**CLINCH RIVER
BREEDER REACTOR PROJECT**

**PRELIMINARY
SAFETY ANALYSIS
REPORT**

VOLUME 20

Figure Q130.62-1 HORIZONTAL SSE GROUND RESPONSE SPECTRA

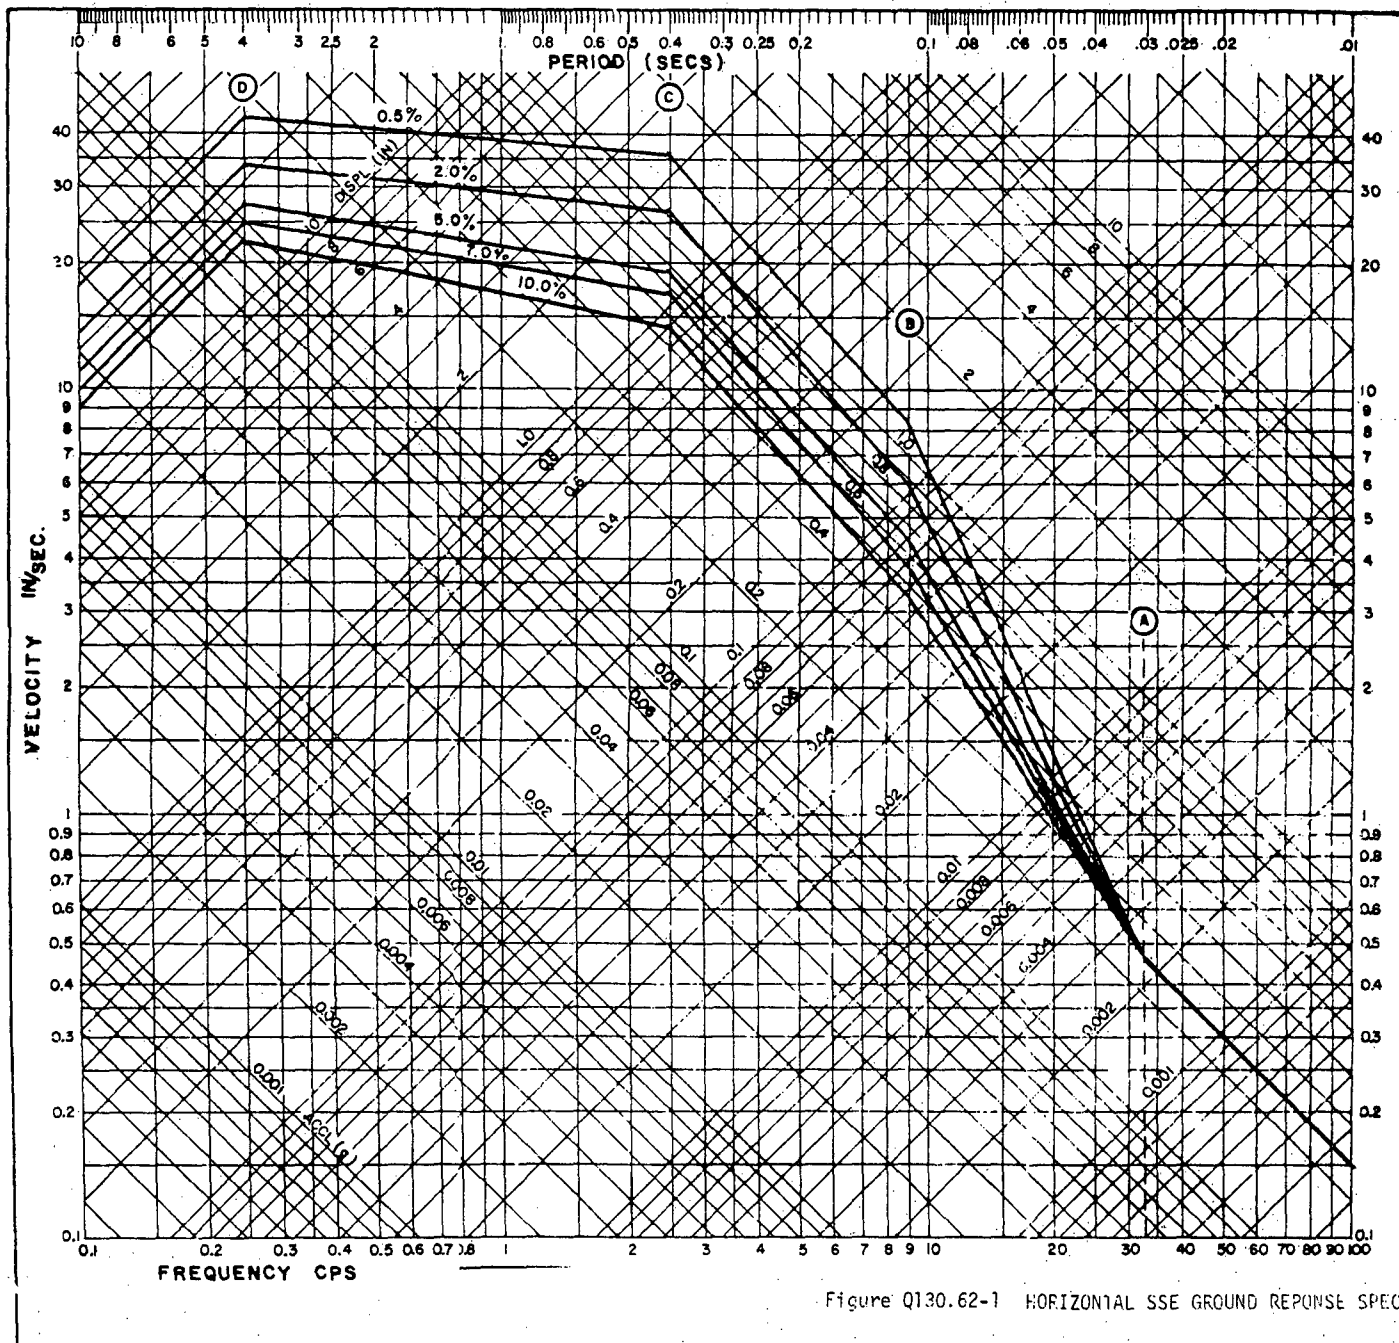
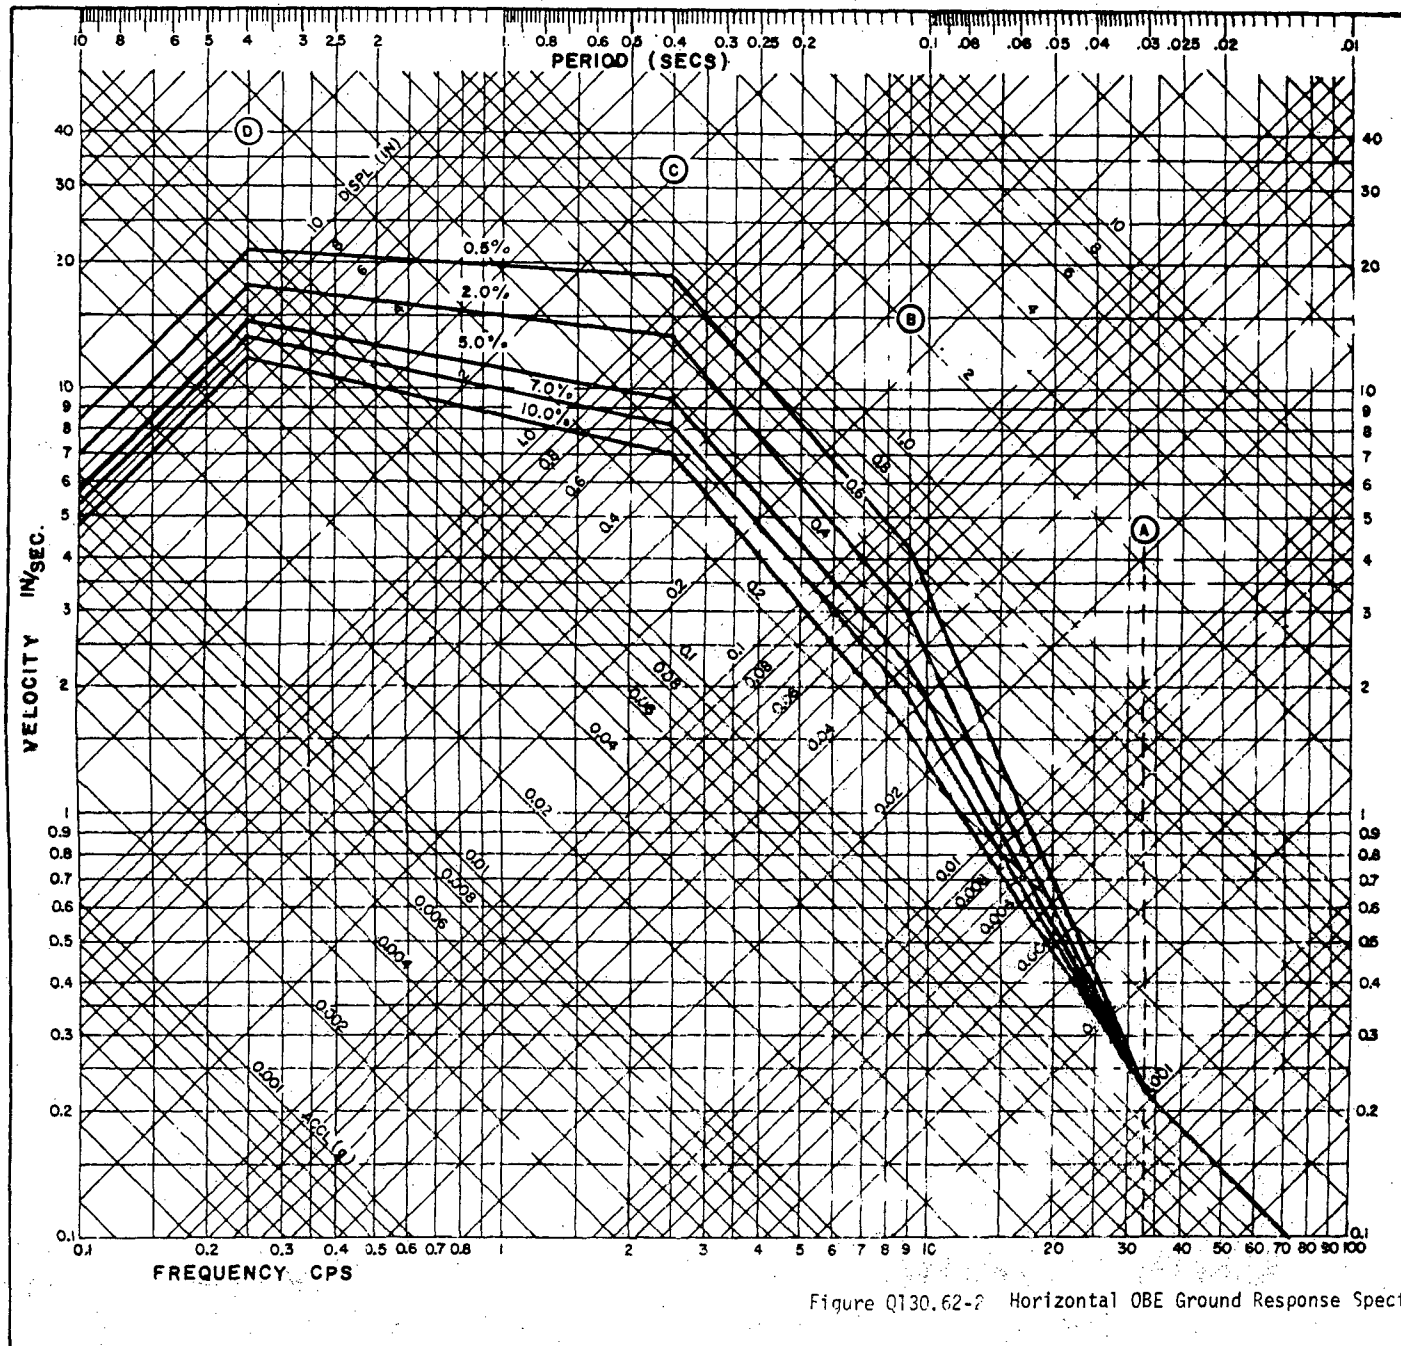
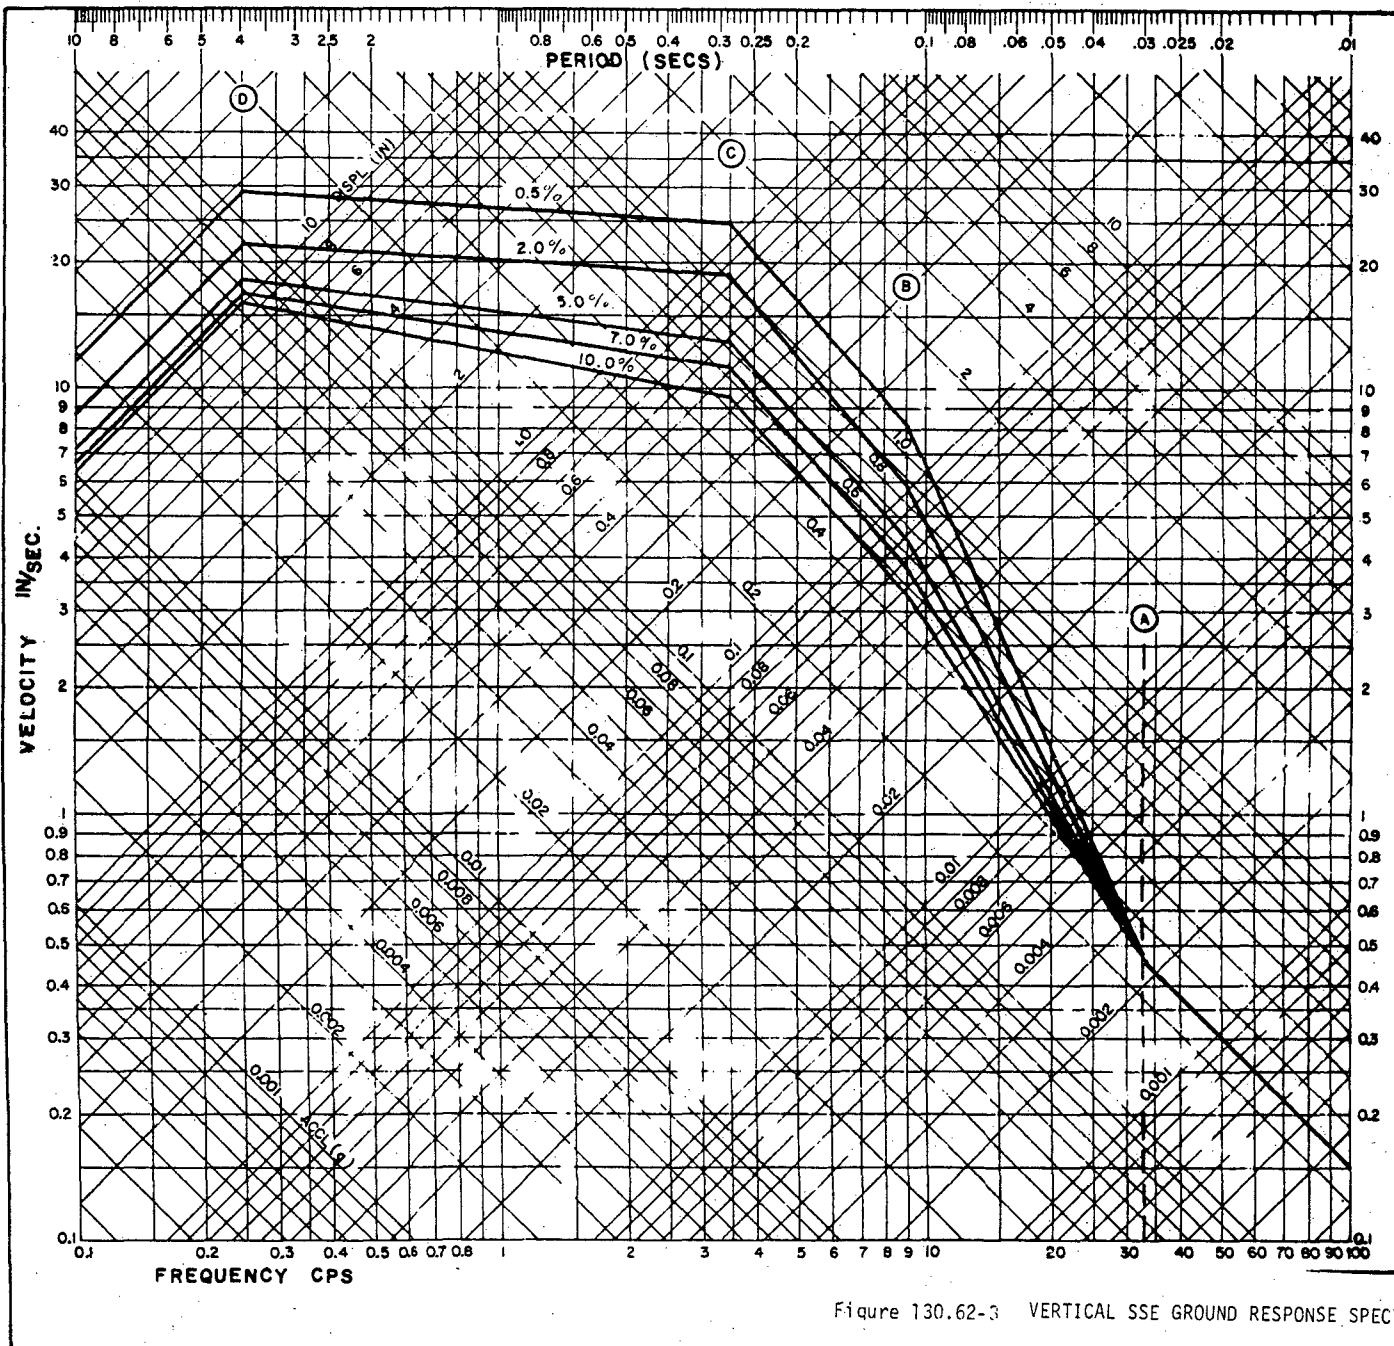
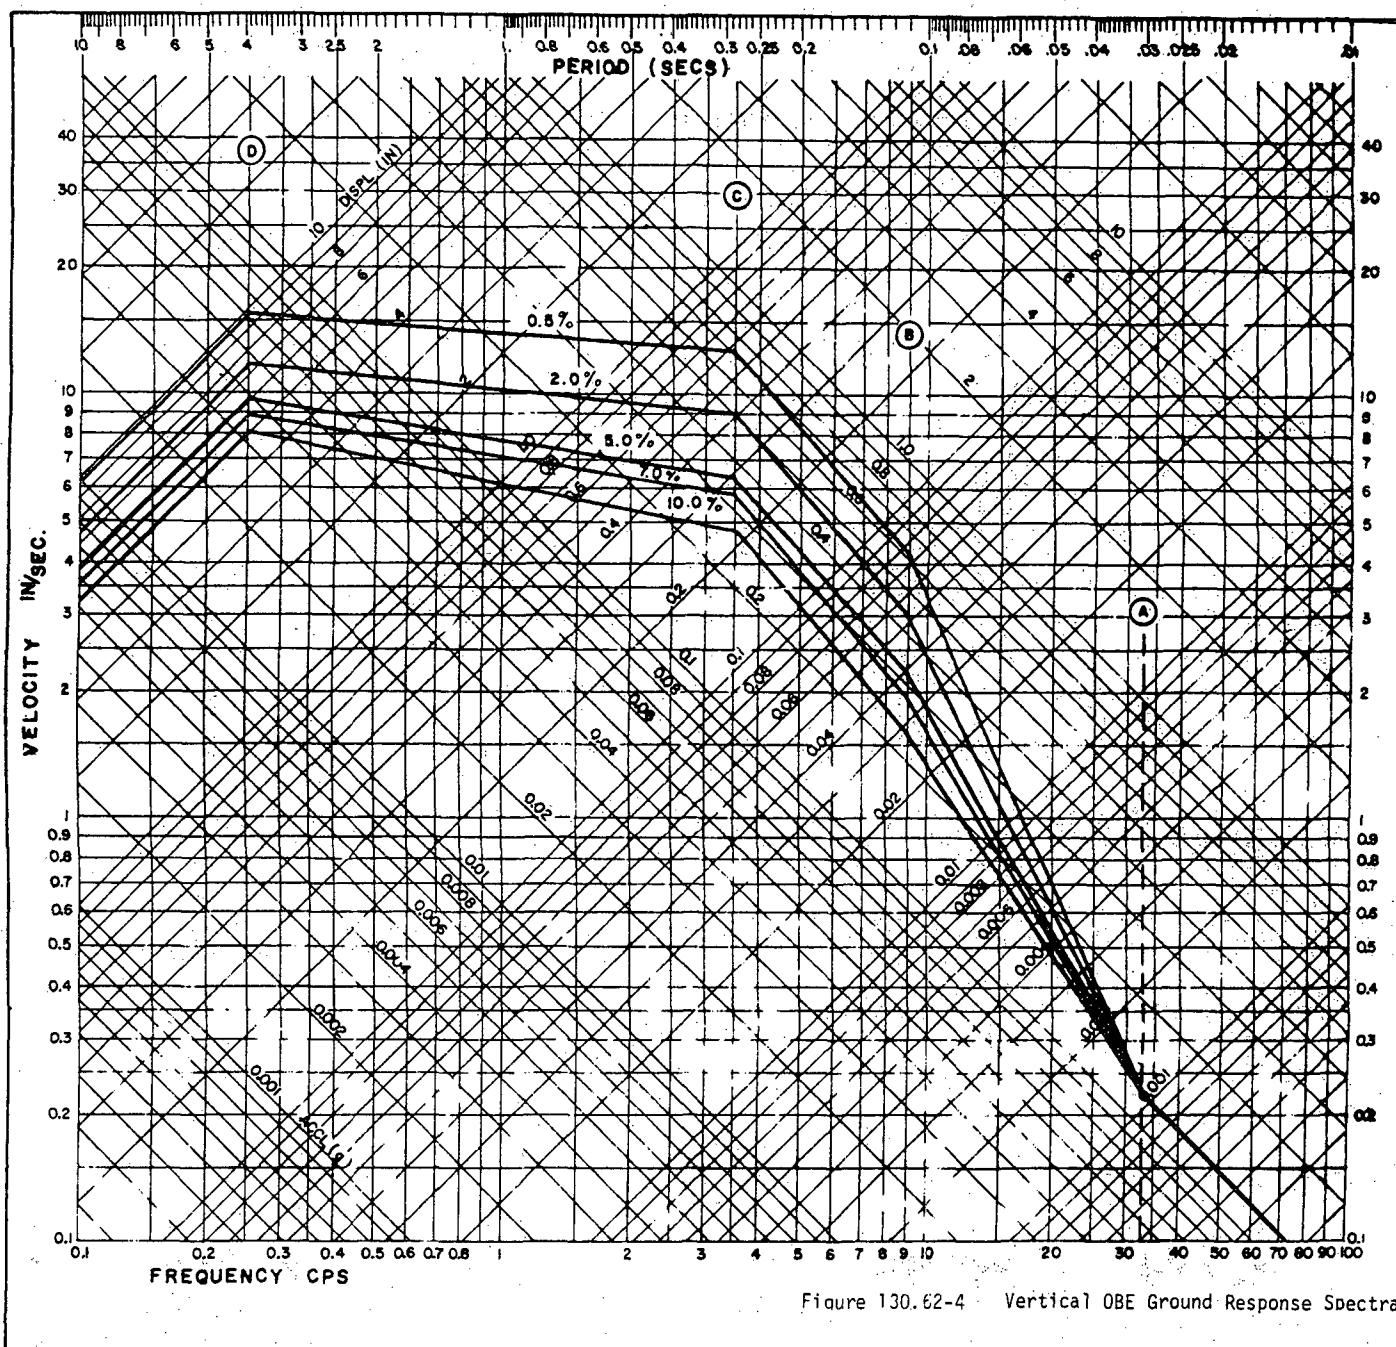
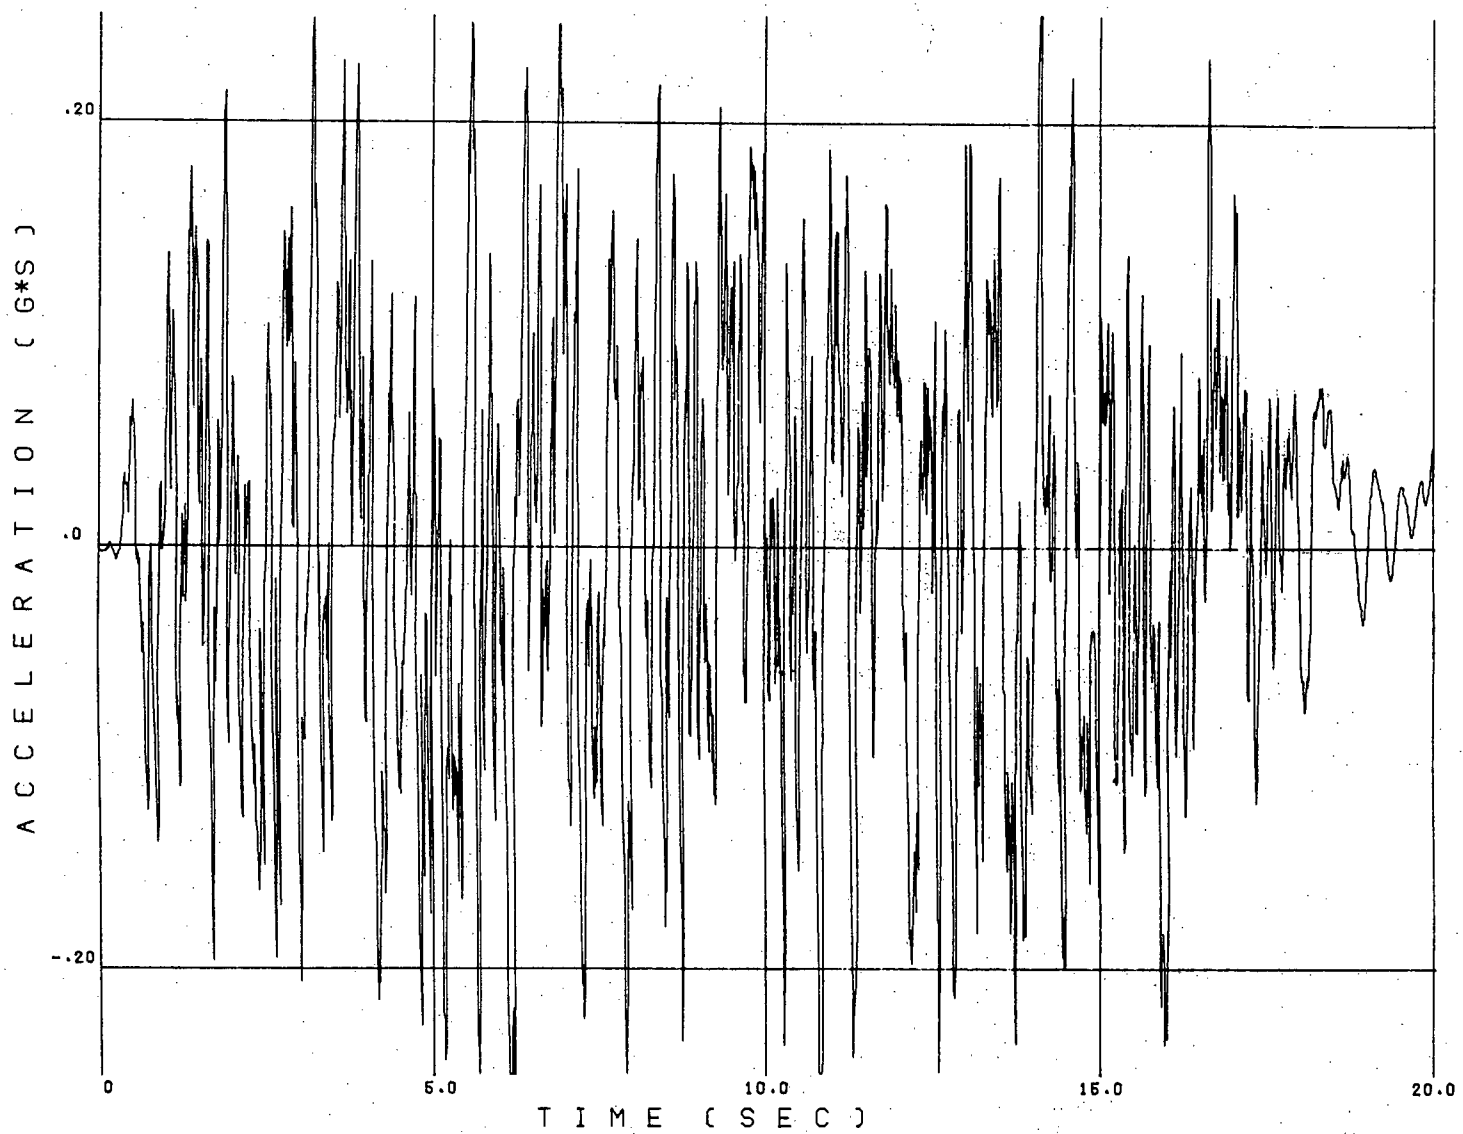
Figs. 3.7A-1, 2, 3, 4, 5 and 6 and Tables 3.7A-1 and -2 should be revised to comply with the 0.25 design ground acceleration value.
